SERVICE BULLETIN 7

MODEL  
GLASAIR FT

SUBJECT: WELDS OMITTED ON GLASAIR FT INBOARD RIB ATTACH BRACKET

FIGURE (1)

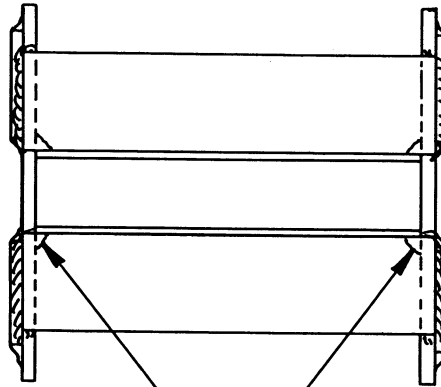
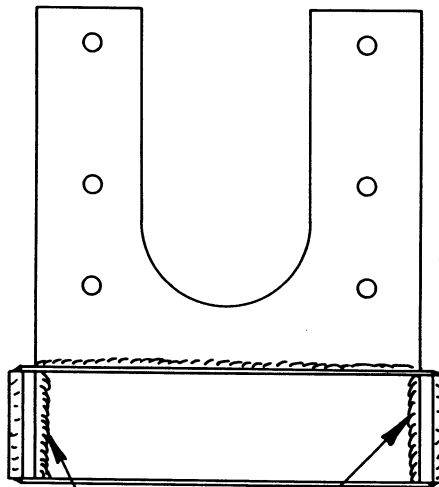
WELDS REQUIRED HERE  
(BOTH SIDES OF BRACKET)

WELDS REQUIRED HERE  
(BOTH SIDES OF BRACKET)

DESCRIPTION: The inboard rib attach bracket delivered with your Glasair FT landing gear hardware omitted four necessary welds. Without these welds, shown in FIGURE (1), the component lacks the necessary strength to withstand possible loads imposed by the landing gear.

SOLUTION: The omitted welds must be completed, using either the oxy-acetylene or gas tungsten arc welding (TIG) process, before the airplane is flown. The builder has the choice of completing these welds himself or shipping the bracket to us for welding in our shop.

Since the cadmium plating will be burned off by welding, the part must either be replated or painted for corrosion protection.
